VILLA ORCHIDS

Details of Additions & Alterations

Villa No	112.	Type	A2	Deluxe / Semi-Deluxe
Buyer Name	B. K. Sumanth Kumar			
Phone No.	9908875137	Email	sumanth.brk@gmail.com

Addition & Alteration Approval Form

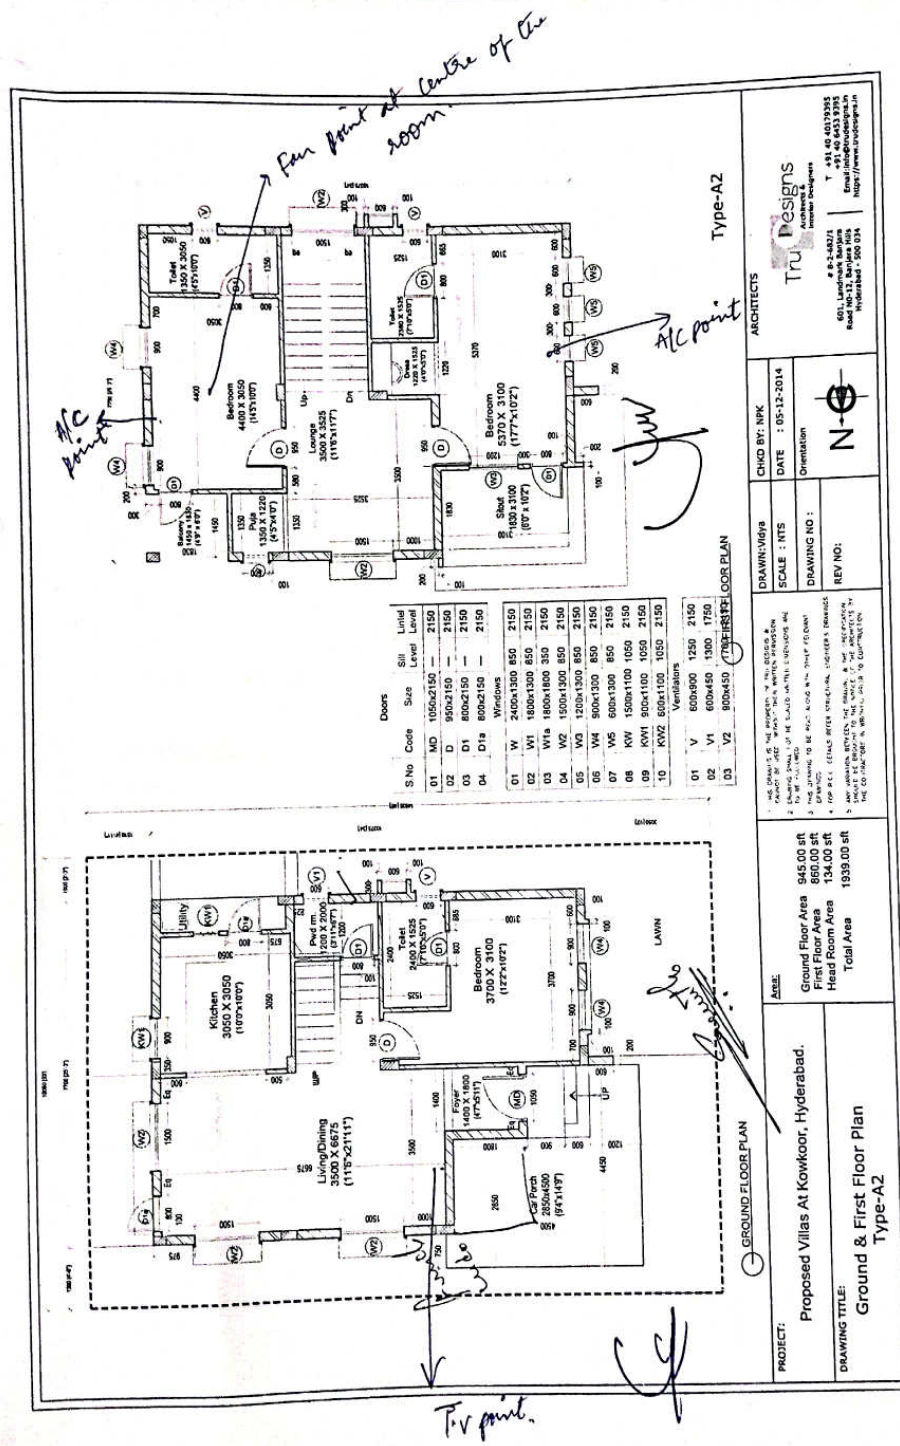
Changes in kitchen platform: (mark on plan)

- ① timing ~~area~~ ^{containing} area more from towards
- ② Hook provision required in two sit-outs.
- ③ light provision in sit-out

- ④ Shift T.V point
- ⑤ light points in front elevation

- ① Malaysian brown tiles tiles in all bathroom
- ② Three terrace window panels (UPVC)

- front window in foyer area

- floor - 11 extension in foyer area

V. NO 112 OLD DRAWING

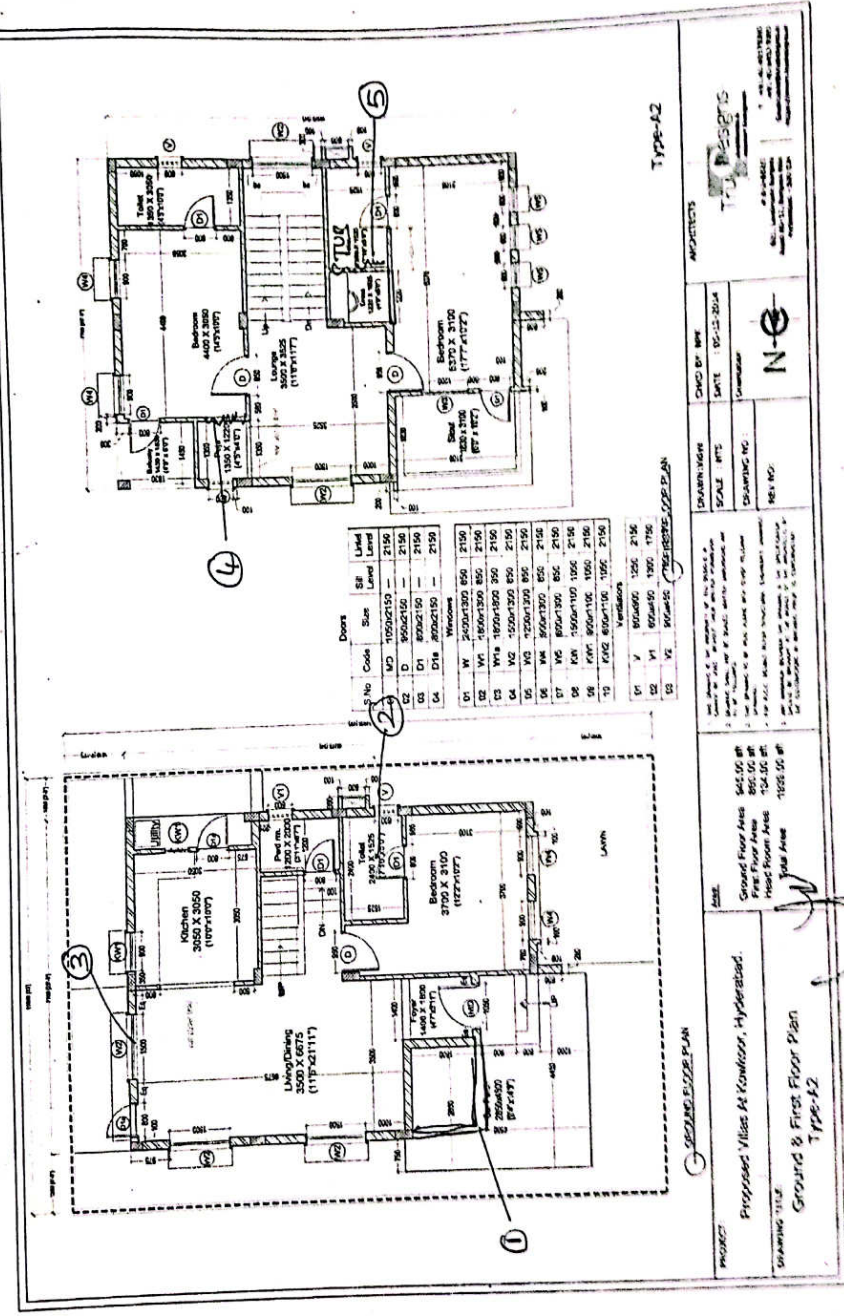
1.	Living Hall extension require up to 5 feet foyer level	No	No	Yes	Yes	No
2.	Guest bedroom toilet not required	Yes	Yes	Yes	No	No
3.	Dining hall east side wall window should be required French window instead of window opening. — depend on super. give opening.	Yes	Yes	Yes	Yes	No

4.	Puja room opening required inside of the children bedroom	Yes	Yes	Yes	Yes	No
5.	Master bed Toilet dress are & toilet club together & provision required for Bath tub.	No	No	Yes	Yes	No
